SI B 11 01 07
Engine

March 2009
Technical Service

SUBJECT

N62 and N62TU Crankcase Ventilation System – Cold Climate Conditions

PROCEDURE A:

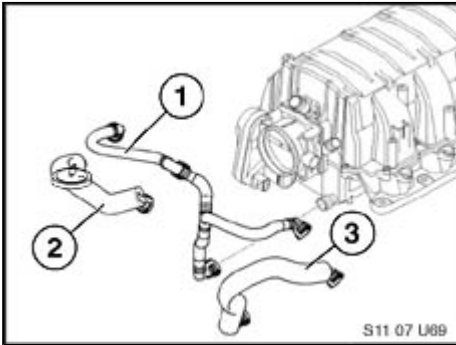
1. Replace the cylinder 1-4 head cover with P/N 11 12 7 563 474 with the updated crankcase ventilation valve.

2. Remove the crankcase ventilation plastic corrugated hose (1) connecting the two cylinder head covers and intake system. Install the modified insulated hose with the external pressure regulating valve (2), using P/N 11 61 7 563 476. Install the insulated hose (3), using P/N 11 61 7 547 186.

PROCEDURE B

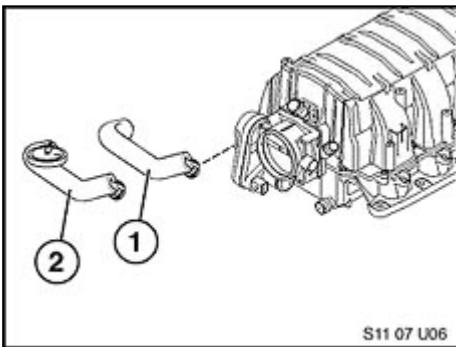
2. 1. Replace the cylinder 1-4 head cover with P/N 11 12 7 563 474 with the updated crankcase ventilation valve.

2. 2. Remove and discard the ventilation hose (1). Install the modified insulated hose with the external pressure regulating valve (2), using P/N 11 61 7 563 476 in the same location.

PROCEDURE C

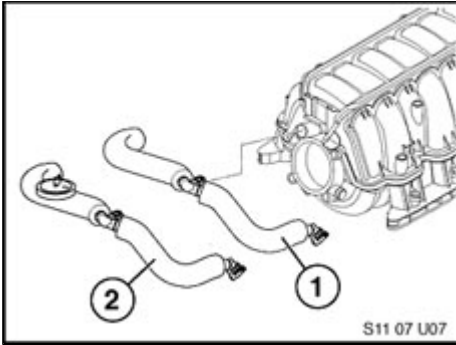
1. Replace the cylinder 1-4 head cover with P/N 11 12 7 563 474 with the updated crankcase ventilation valve.

- Remove the ventilation hose (1). Install the modified insulated hose with the external pressure regulating valve (2), using P/N 11 61 7 563 477 in the same location.
